Jamuna Apparels Ltd. (Extension Buildings)

94/95 (Old), 46 (New), Block - C, Tongi Industrial Area, Tongi
(23.900612, 90.400296)
27th Sept 2021

Buildings Information

No framing/bracing system/load transfer media provided along long direction

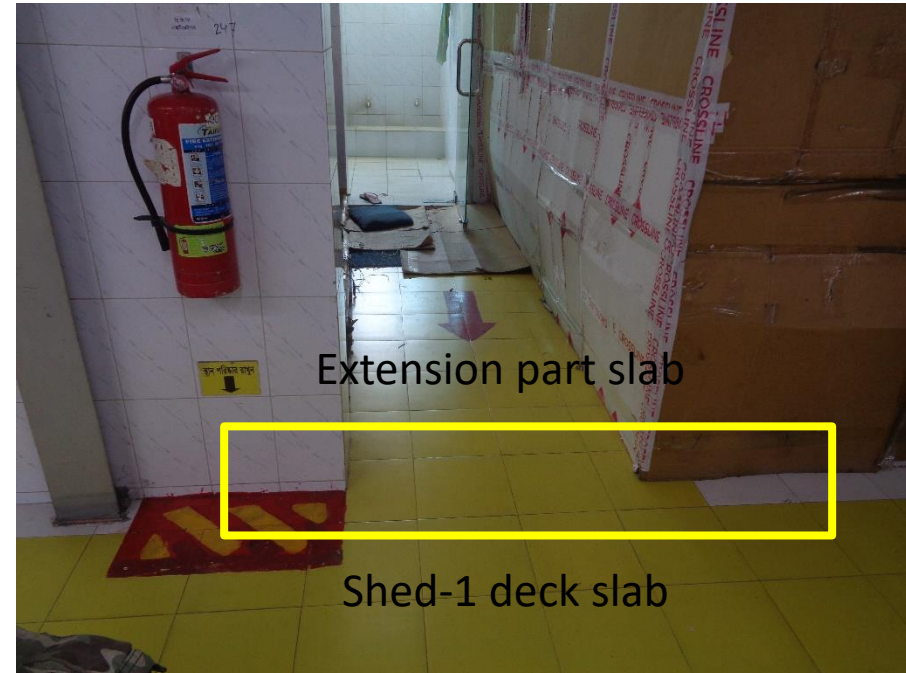
Lateral stability is provided by truss frame action only along the short direction but there is no framing/bracing system/load transfer media provided along the long direction to transfer the lateral load therefore there is no obvious lateral stability system along long direction. In addition, details of truss connection to brick wall is not provided in the drawing. Factory engineer is required to check the lateral stability of this shed. Also, check the connection adequacy for all steel connections.
